HISTORIC AND DESIGN REVIEW COMMISSION

HDRC CASE NO: 2020-134
ADDRESS: 402 CENTER ST
406 CENTER ST
120 N CHERRY ST
122 N CHERRY ST
126 N CHERRY ST
129 N SWISS
LEGAL DESCRIPTION: NCB 590 BLK 3 LOT N 40 FT OF 1
ZONING: IDZ, H
CITY COUNCIL DIST.: 2
DISTRICT: Dignowity Hill Historic District
APPLICANT: Ricardo Arjona/Terramark Urban Homes Charles
OWNER: Turner/K/T TX HOLDINGS LLC & New
TYPE OF WORK: construction
APPLICATION RECEIVED: March 16, 2020
60-DAY REVIEW: Not applicable due to City Council Emergency Orders
CASE MANAGER: Edward Hall
REQUEST:

The applicant is requesting a Certificate of Appropriateness for approval to construct six, 3-story residential structures on the vacant lot bounded by Center Street to the north, N Cherry Street to the west, and N Swiss Street to the east.

MASTER SITE PLAN -
PHASE 2

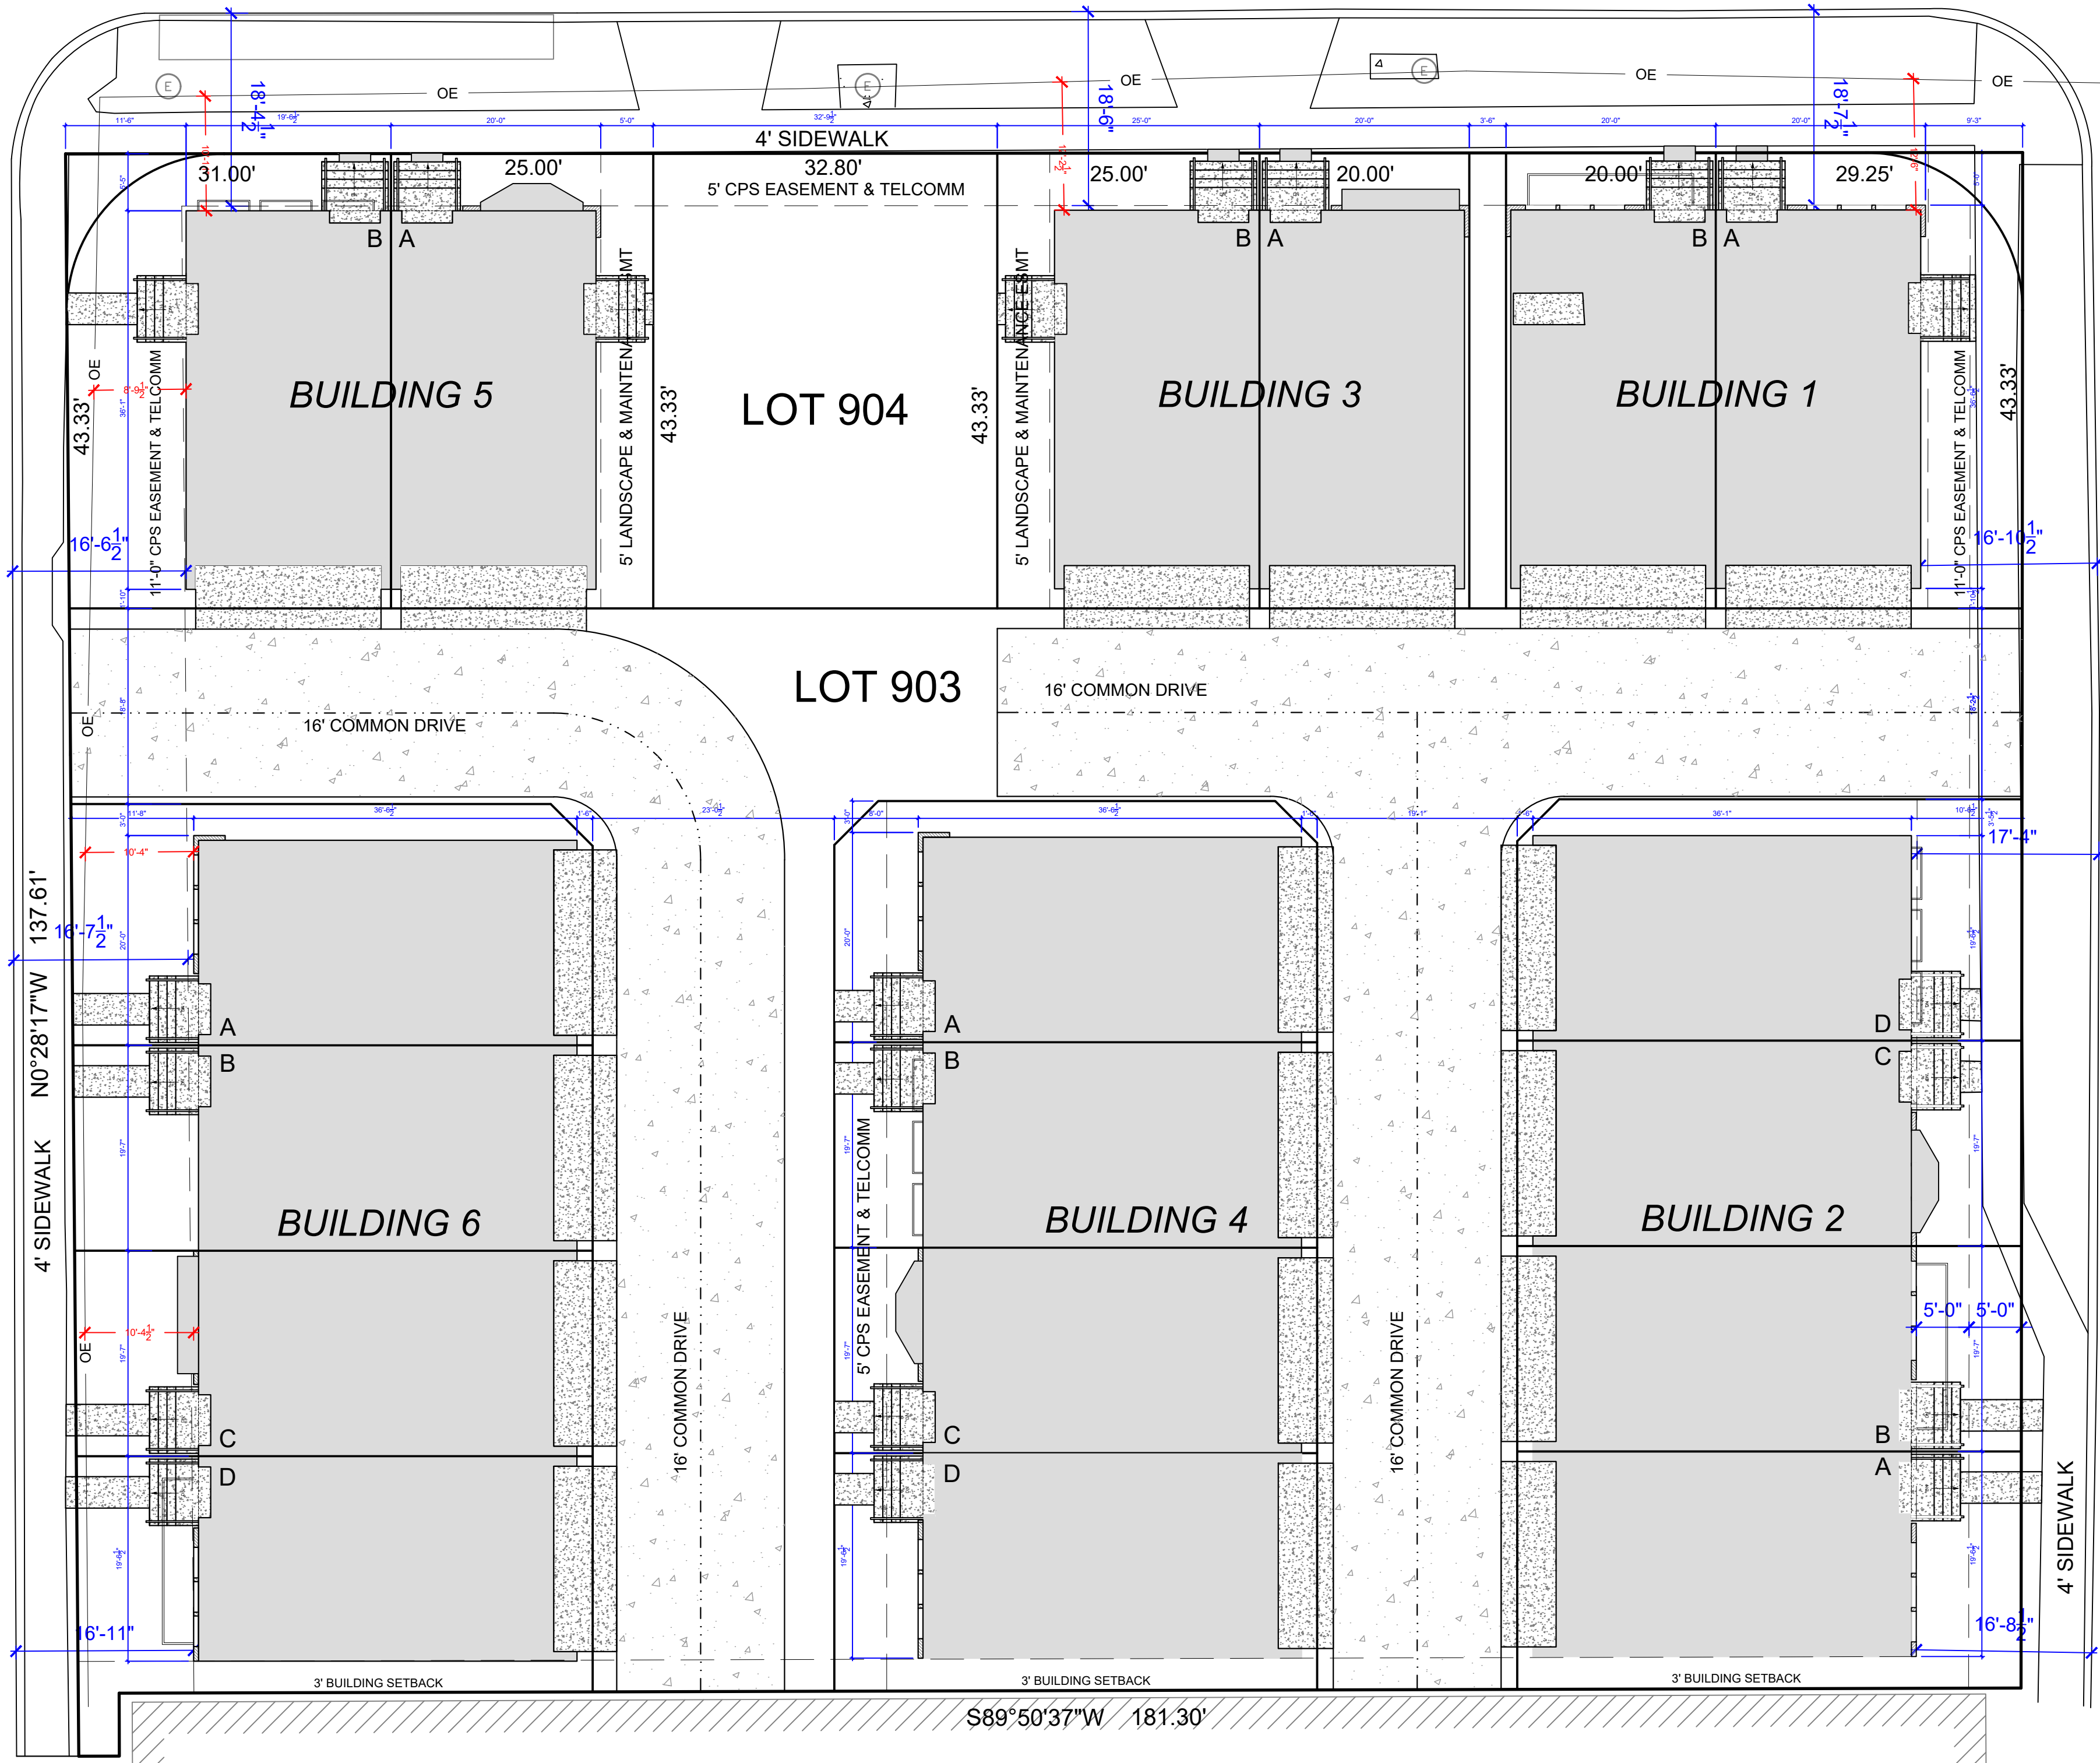
- l. DRIVEWAY – The applicant has proposed a common driveway to feature eighteen (18) feet in width to provide vehicular access into the site. While wider than recommended by the Guidelines, staff finds that there is not an established pattern for driveways on this block, and finds the proposed curb cut and driveway width to be appropriate.

- m. SIDEWALKS – The applicant has noted that each unit will feature a porch/stoop element. Where these elements are oriented toward a primary street (Center, N Cherry, and N Swiss), the applicant has noted the installation of a walkway to connect to the sidewalk at the public right of way. Staff finds this to be appropriate.

MASTER LANDSCAPE
PLAN PHASE 2

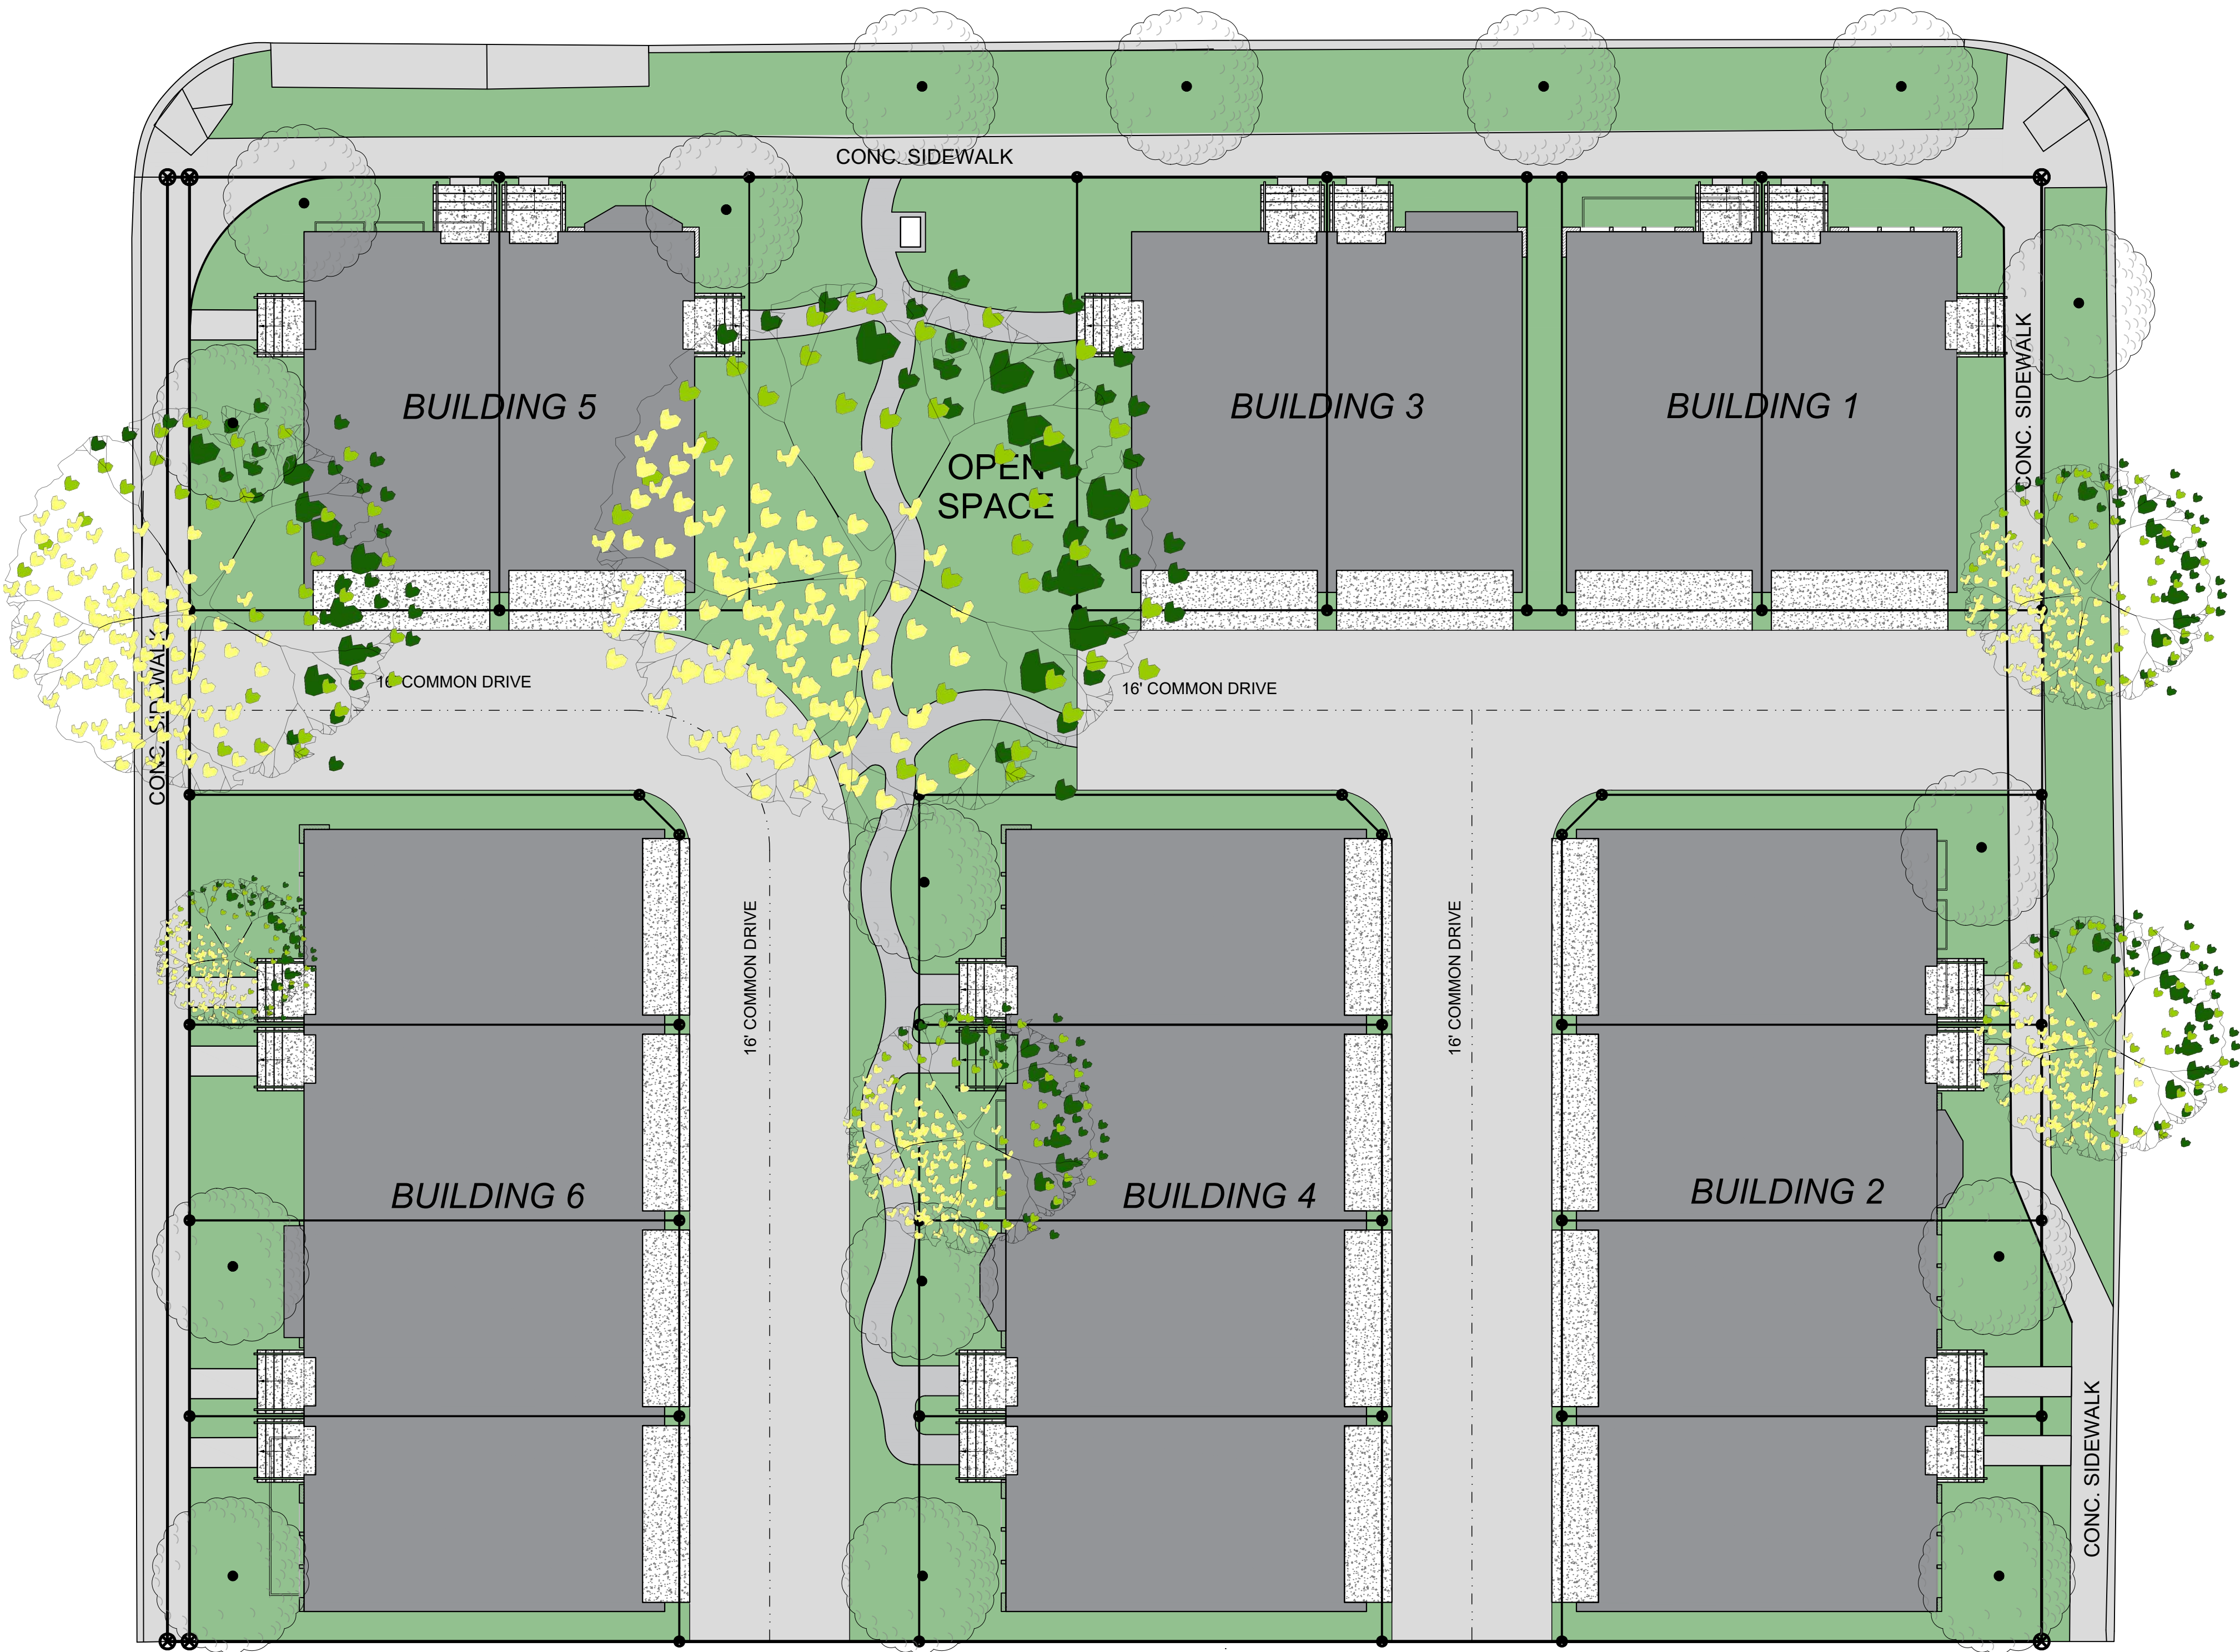
- n. LANDSCAPING – The applicant has submitted a rendered site and landscaping plan noting the installation of natural turf and walkways. Any additional landscaping elements must obtain a Certificate of Appropriateness.
- o. MECHANICAL EQUIPMENT – Per the Guidelines for New Construction 6., all mechanical equipment should be screened from view at the public right of way. The applicant is responsible for screening all mechanical equipment where it cannot be viewed from the public right of way.
- p. GARAGE DOORS – The applicant has proposed garage doors to be located at the rear of each unit where they are generally screened from the public right of way. Staff finds that the proposed garage doors should feature a non-white color, and match colors used throughout the proposed new construction.

Window Detail (Alum.)

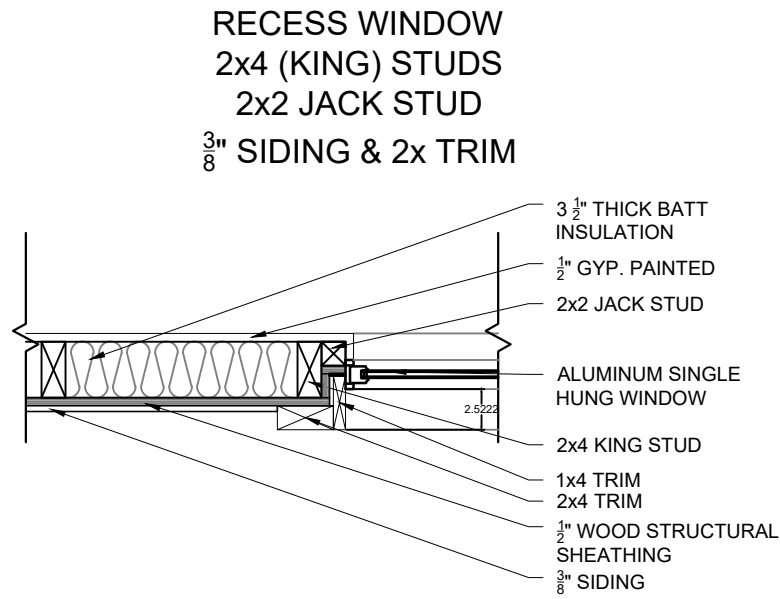
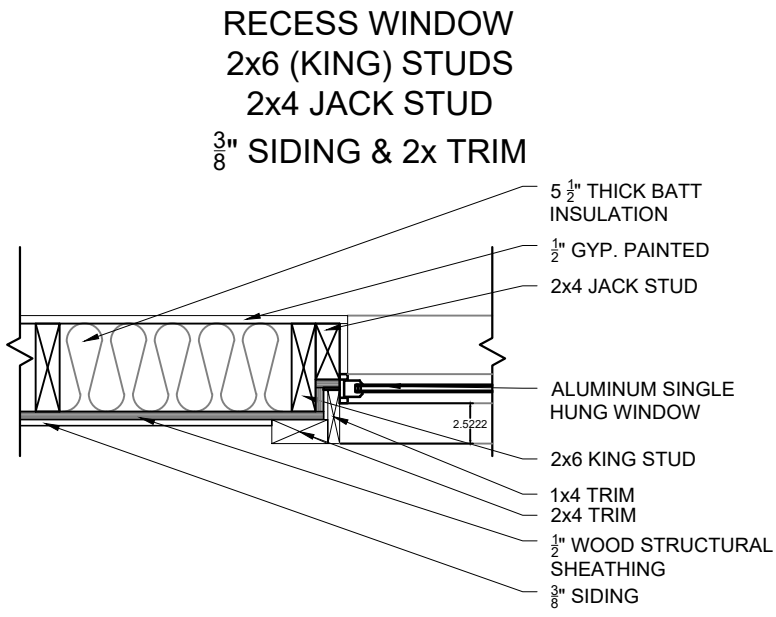
- k. WINDOW MATERIALS – The applicant has proposed to install aluminum windows to match in profile and installation as those approved by the HDRC on November 7, 2018, for use in phase one of this development. The applicant confirmed installation depths through a mockup, which OHP staff reviewed.
